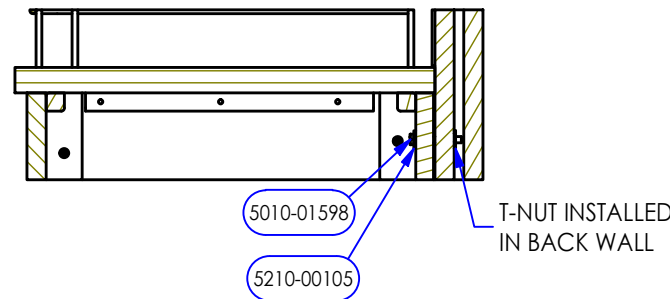
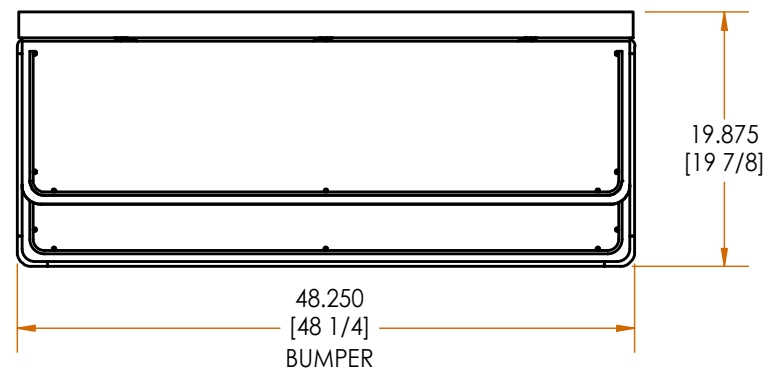
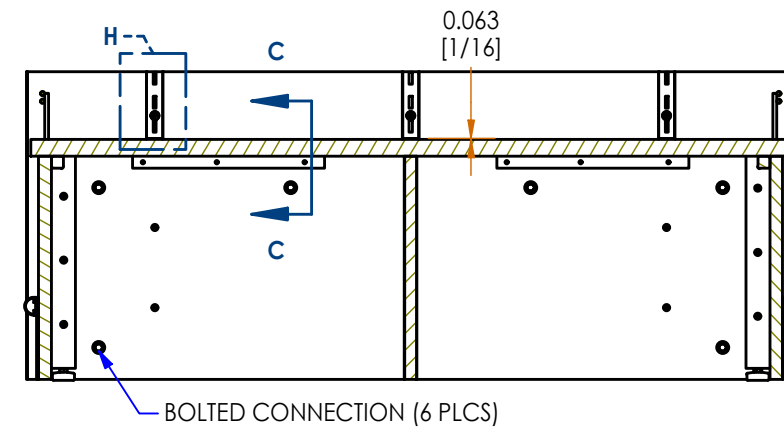
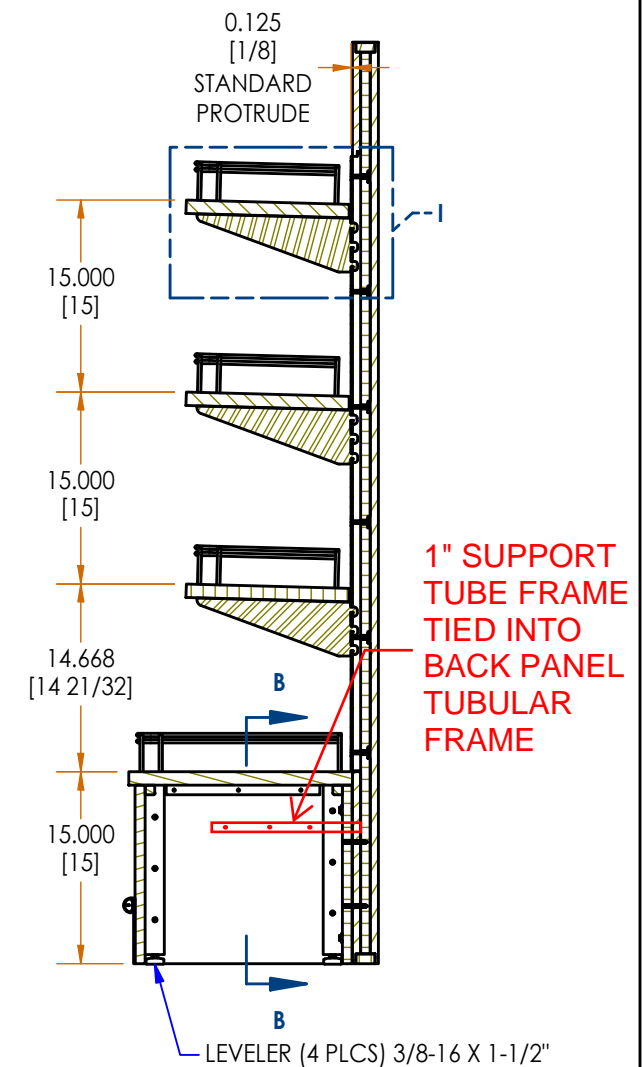
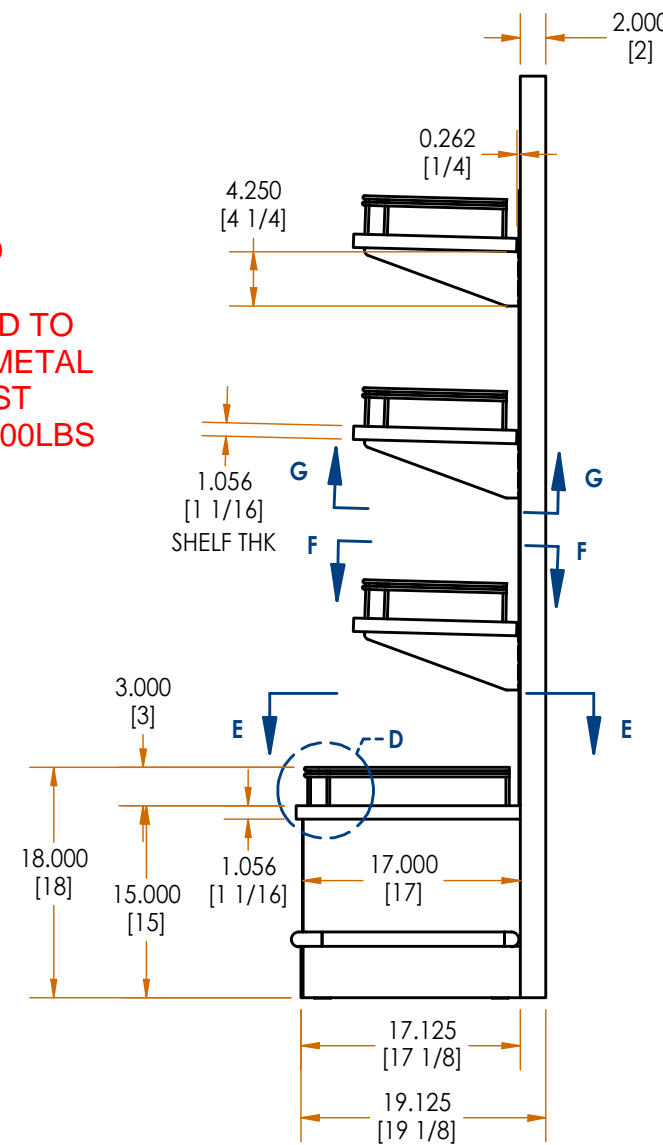
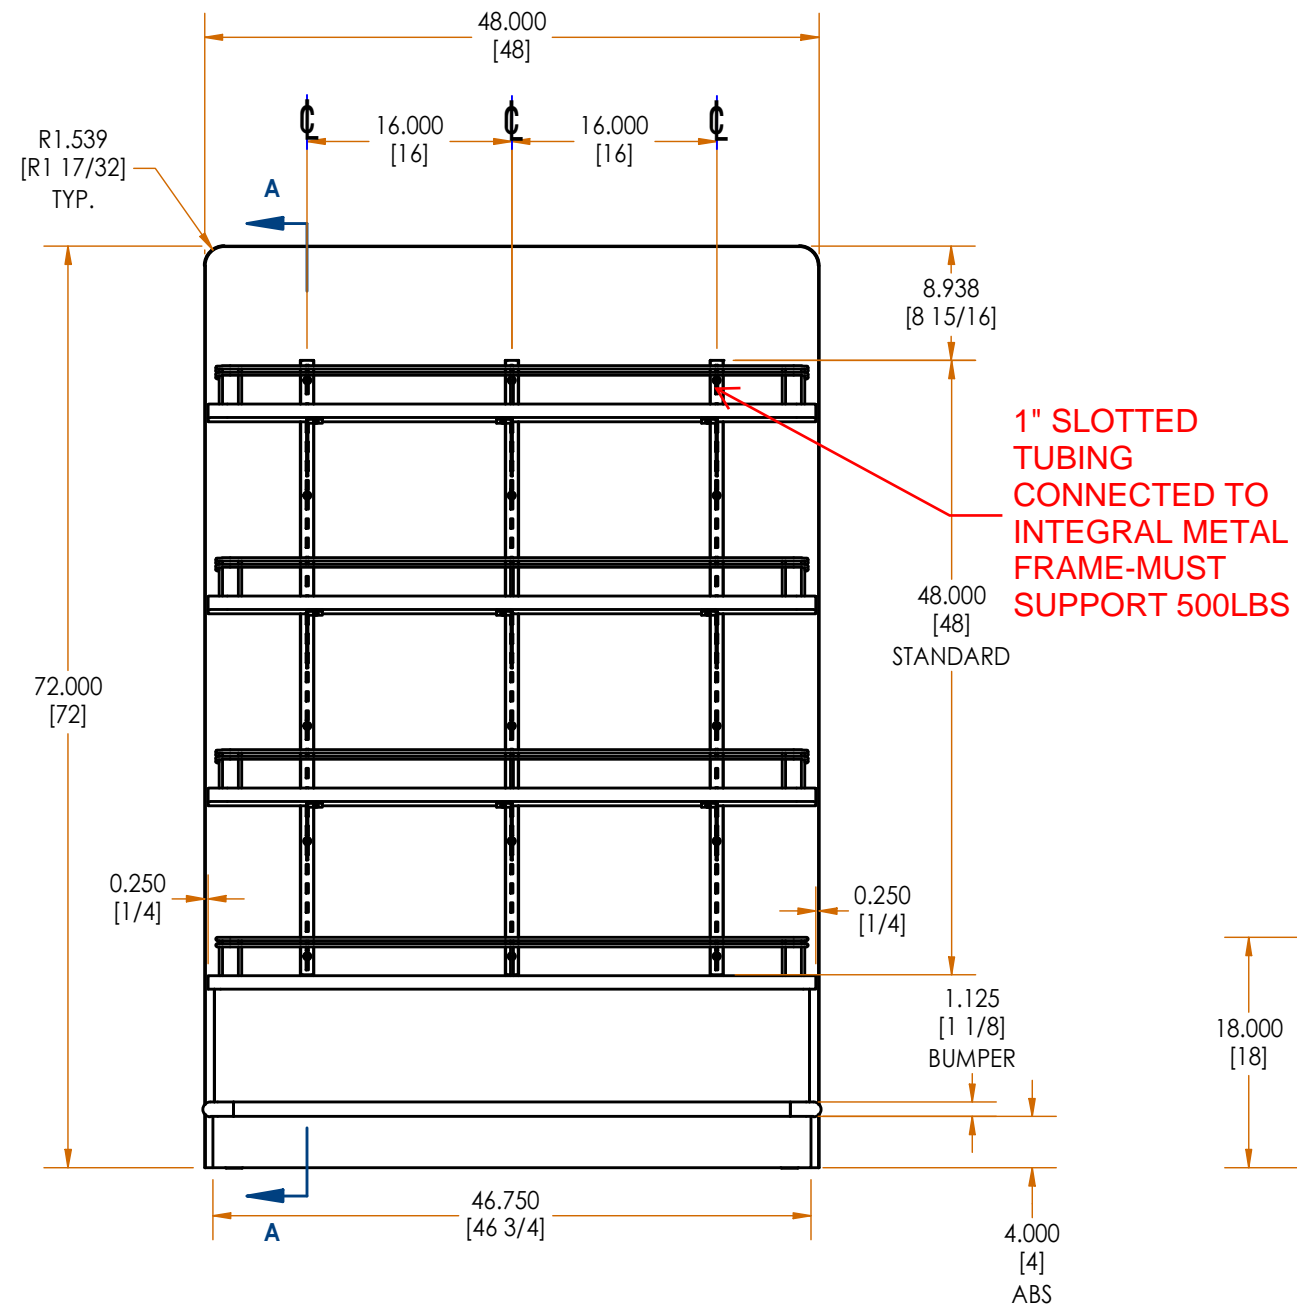
REV	DATE	DESCRIPTION	BY	ECO
1	8/26/2020	APPROVED FOR PRODUCTION - REMOVED SUBMITTAL STAMPS; CHANGED 5/16-18 HARDWARE TO 1/4-20 TO KEEP COMMON HARDWARE IN UNIT	SCC	N/A
2	9/4/2020	REVISED END CAP BACK ASSEMBLY (S0006722) FOR WIDER ROUTS AND WIDER WIDTH OF BUILDUP COMPONENT BY 1.5" FOR MORE GLUE SURFACE	SCC	N/A
3	9/10/2020	CHANGED FROM EB-13 (0.5mm) TO EB-14 (1mm) EDGEBANDING-COMPONENTS IN S0006733, S0006722, & S0006723 UPDATED FOR EB CHANGE	SCC	3412
